# 1200 Pike

**Design Review Board Meeting**  
**1200 E Pike Street | SEATTLE, WASHINGTON 98122**

TARRAGON | 1200 PIKE LLC | ANKROM MOISAN ARCHITECTS, INC.  
AUGUST 14, 2013

# 1. Architectural Concept

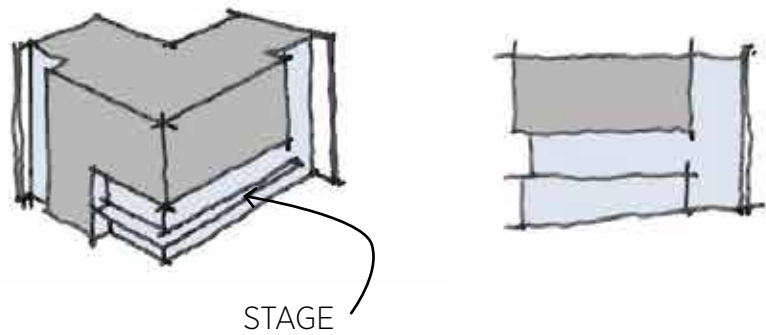
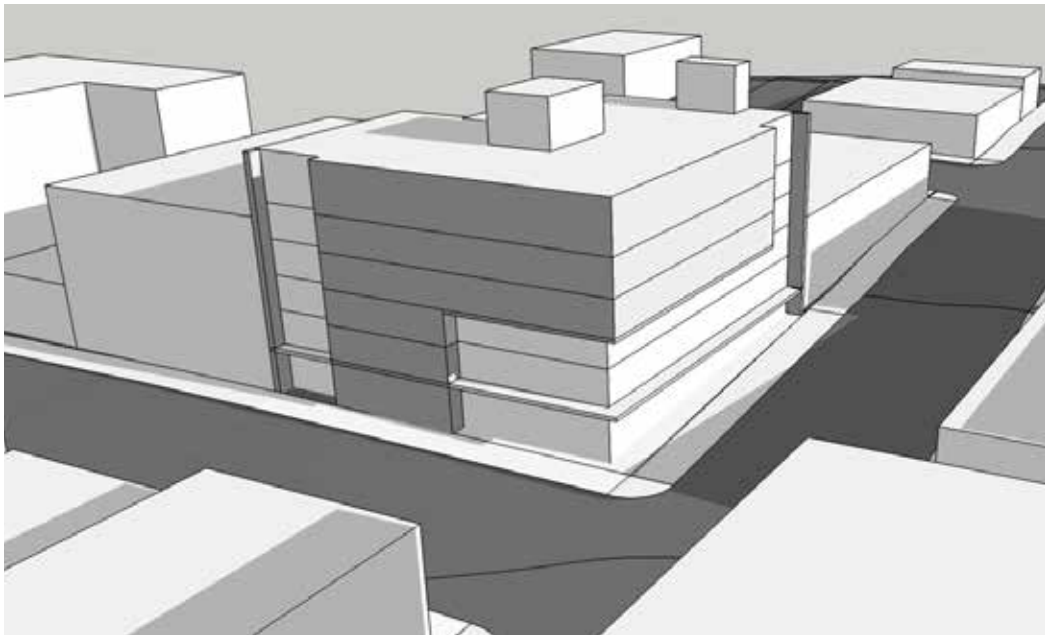
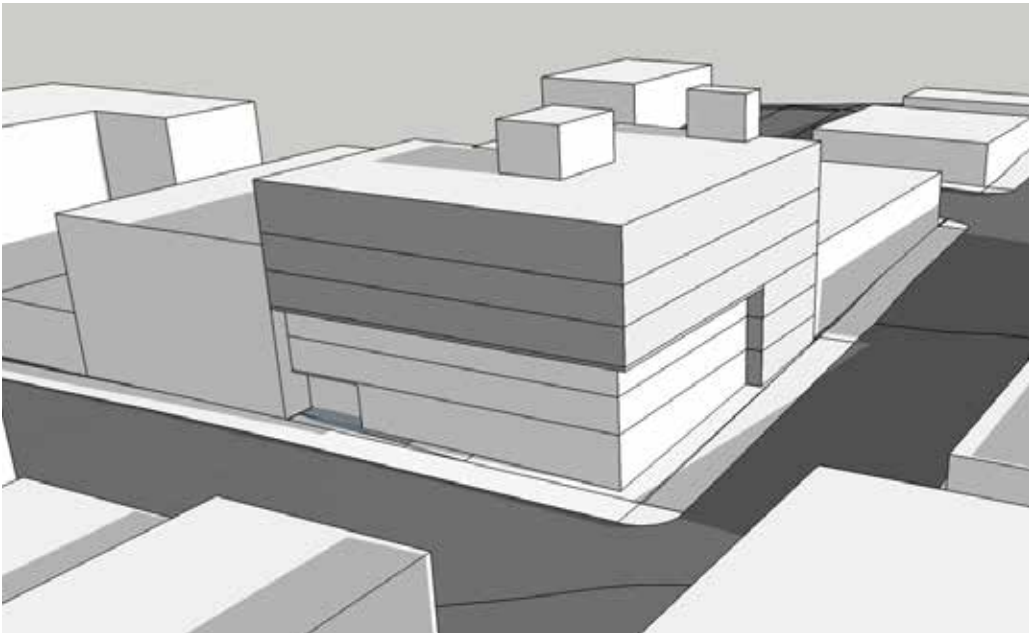
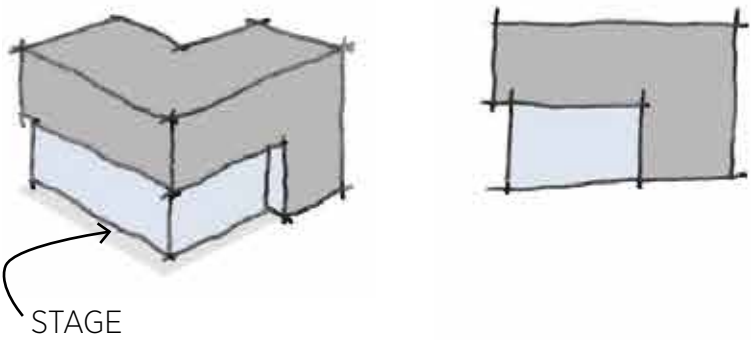
- “The massing relates strongly to the architectural concept and therefore Option 3 appears to be the most appropriate.”
- “The applicant should demonstrate a strong parti/design concept at the Recommendation phase of review. The design concept should be demonstrated through architectural elements, rather than just graphics explaining the inspiration.”

- “The Board noted that the strong design concept should be evident in the building scale, proportion, and architectural elements.”
- “The Board directed the applicant to develop the design in one of two directions: a modern building with its own strong design concept that includes scalar references to Pike Pine and a design concept that strongly references the treatments found in nearby historic architecture.”

- “The fin walls could incorporate unique building identification signage, but any signage should be integrated with the design concept. The large fin wall signage should not include “live here” type of advertisements.”

- “The fin walls serve to frame the residential entry and garage entry bays. The development should be designed to enhance the ‘box’ concept, with the fin walls framing these areas.”

GENERAL MASSING

- 3-PART PARTI - BASE | MIDDLE | TOP
- RECESSED | OPEN EDGES WITH FIN WALLS
- SEVERAL RECESSED ELEMENTS

GENERAL MASSING

- REMOVED SLAB EXPRESSION AT SECOND FLOOR
- REMOVED 'FIN WALLS' AND RECESSED EDGES
- 2-PART PARTI - BASE | TOP
- 1 SIMPLIFIED RECESS

## 2. Scale & Proportion

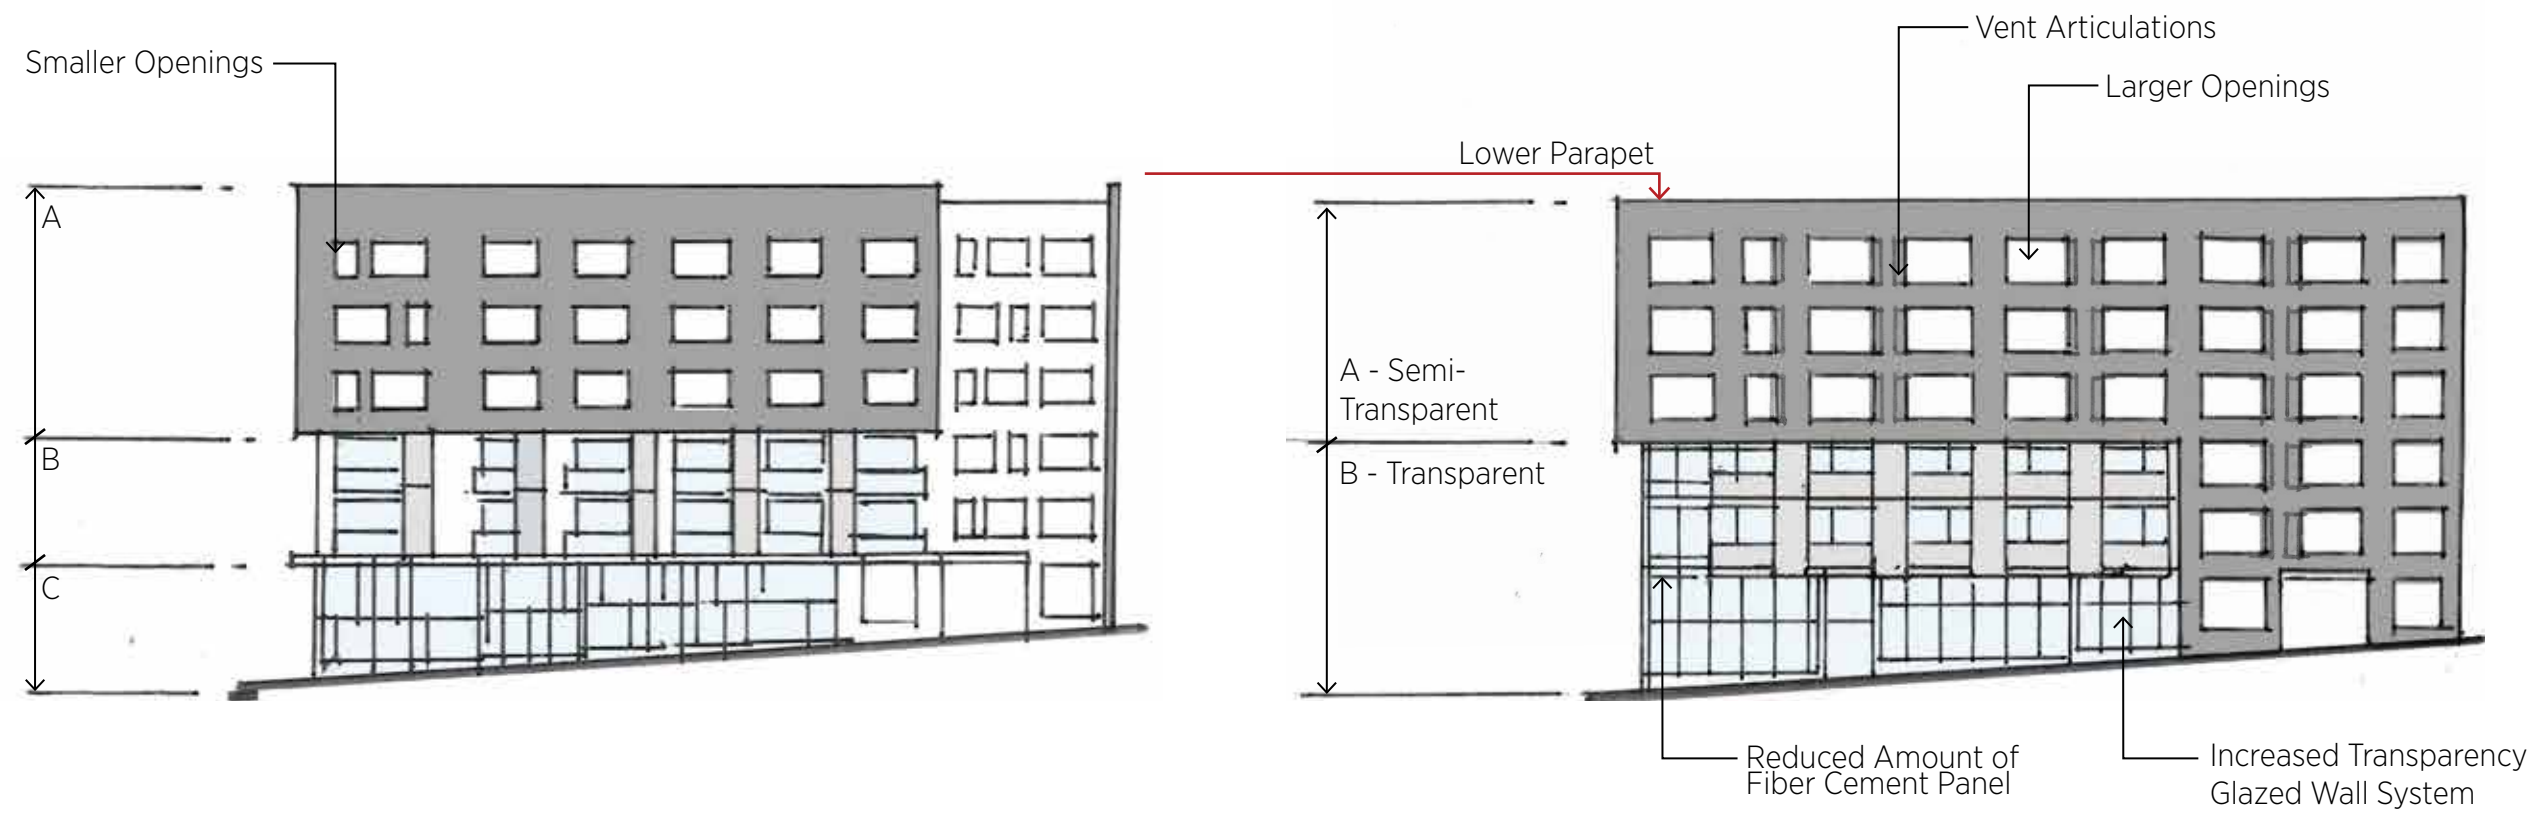
- “Option 3 is the best design response to the corner condition, but the upper mass feels very heavy, especially at the corner. ”
- “The design should maximize the visual height and transparency of the street level, and reduce the visual weight of the upper mass.”
- “The Board suggested that the lower three stories could express one concept with tall ceiling heights and increased transparency, with a visually lighter treatment at the upper mass to balance the overall proportion”
- “The garage entry should be designed with visual cues to maximize pedestrian and driver safety.”

E PIKE STREET ELEVATION DIAGRAM | BAY SPACING

12TH AVENUE ELEVATION DIAGRAM | BAY SPACING

SOUTH ELEVATION - EARLY DESIGN GUIDANCE

SOUTH ELEVATION - DESIGN REVIEW

## 3. Retail

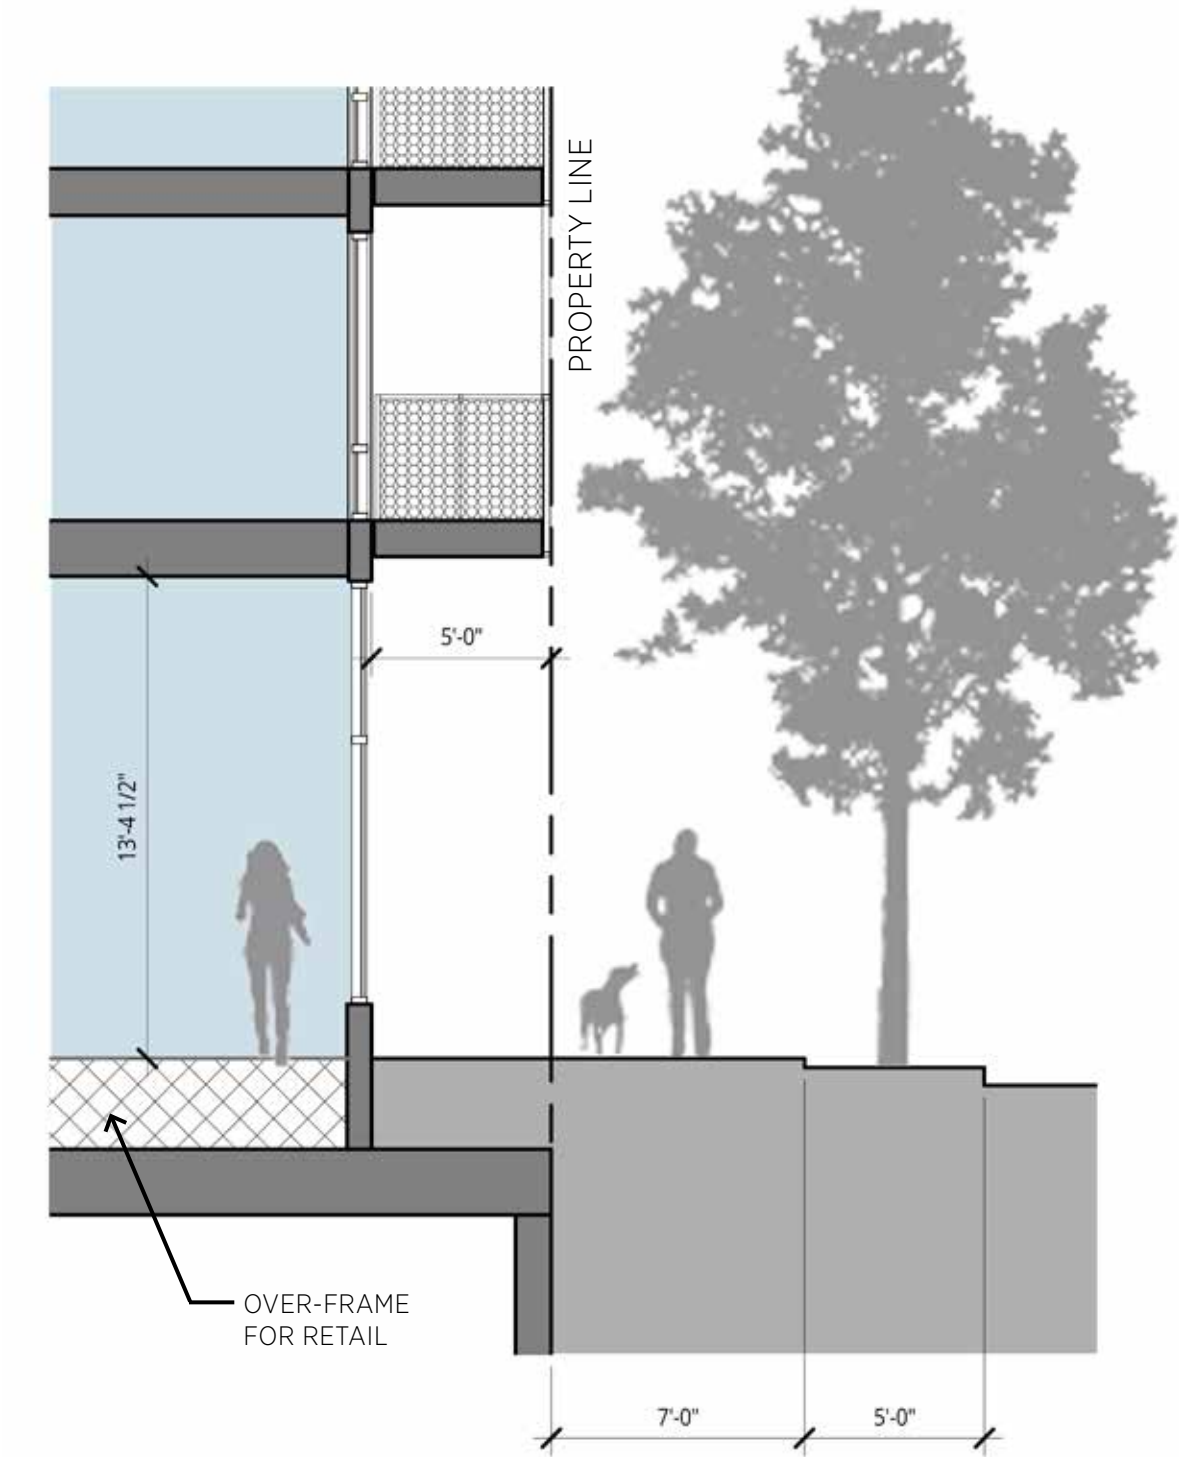
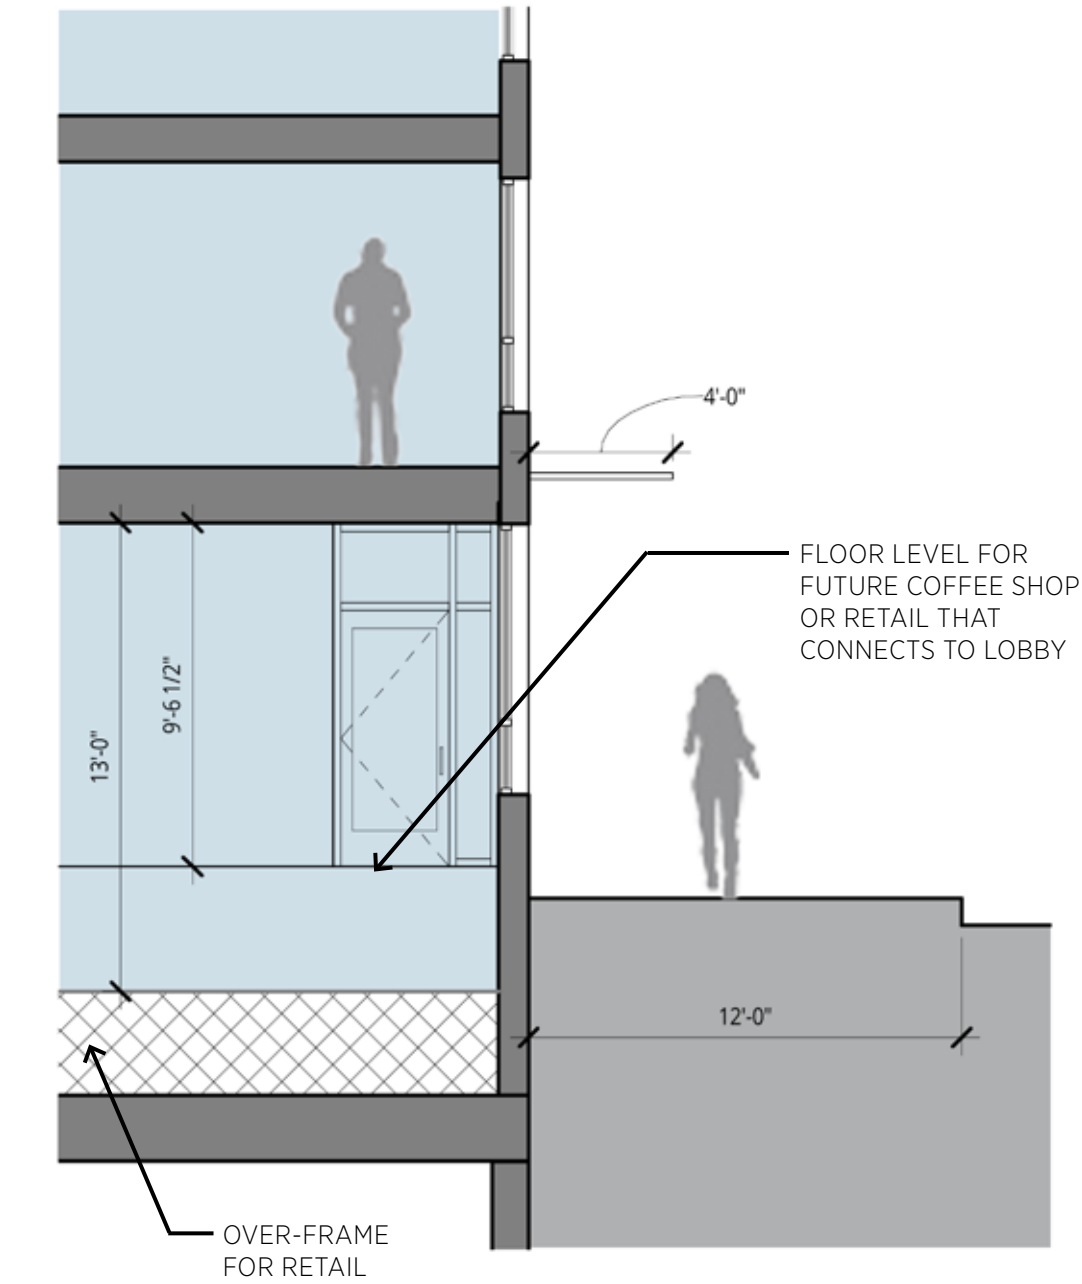
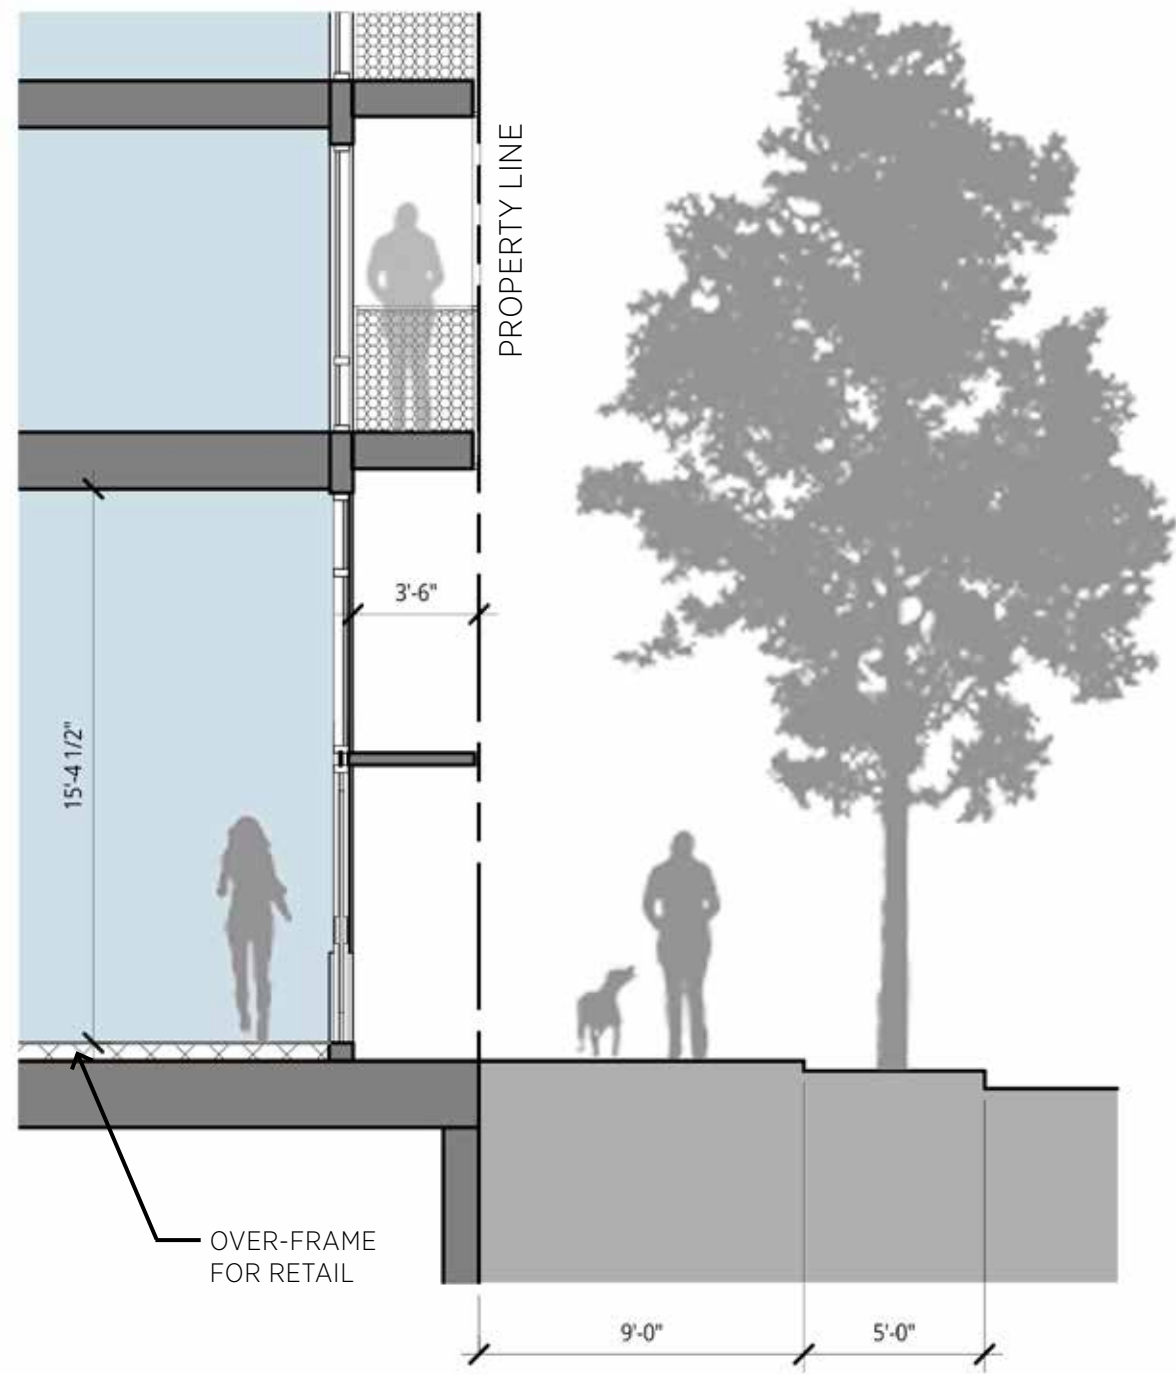
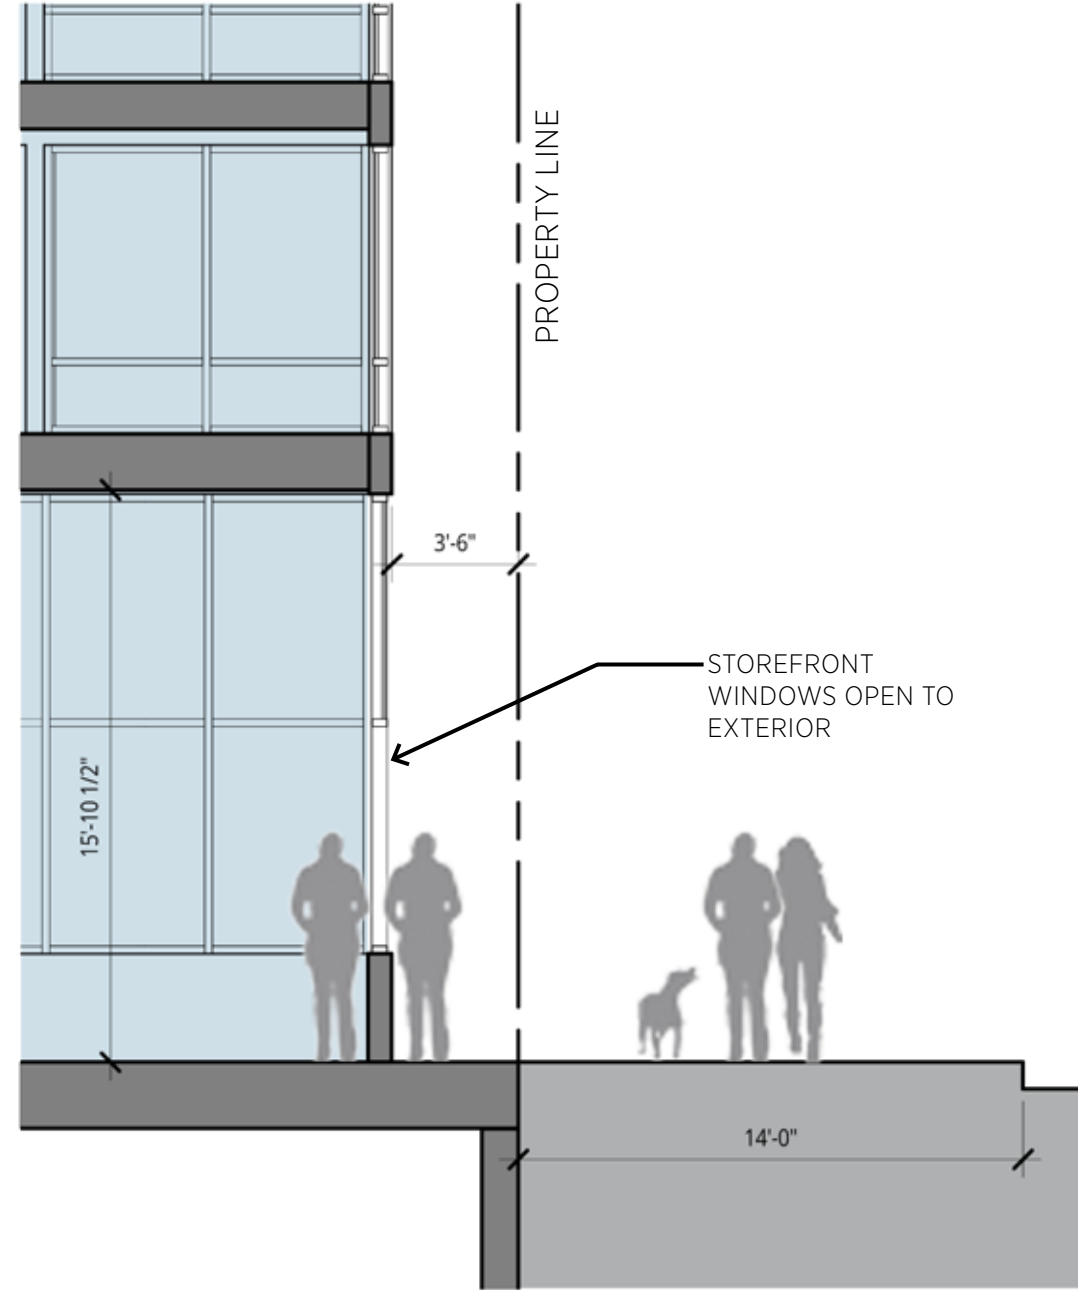
- “The Board directed the applicant to demonstrate how the retail spaces will be designed in response to the sloping sidewalk (stepped slab, etc.).”
- “The commercial spaces should be designed to provide opportunities for micro retail and flexibility for other uses.”
- “The graphics showing opportunities for finer grain small retail indicates the design is moving in the right direction.”
- “The Board noted that design of the sidewalk area is important, given the context and location of this site.”
- “The Board expressed concern with the proposed solid waste alcove facing 12th Ave at street level. The Board directed that solid waste storage should be placed into a holding area behind the retail frontage, and could be accessed from the garage ramp or garage.”
- “The solid waste storage should not be a prominent part of the street frontage, regardless of the location.”

- Retail layouts, door locations, and pavement demarcations will be determined by future tenants
- The design allows for future opportunities for the lobby and adjacent retail space to flow into one another
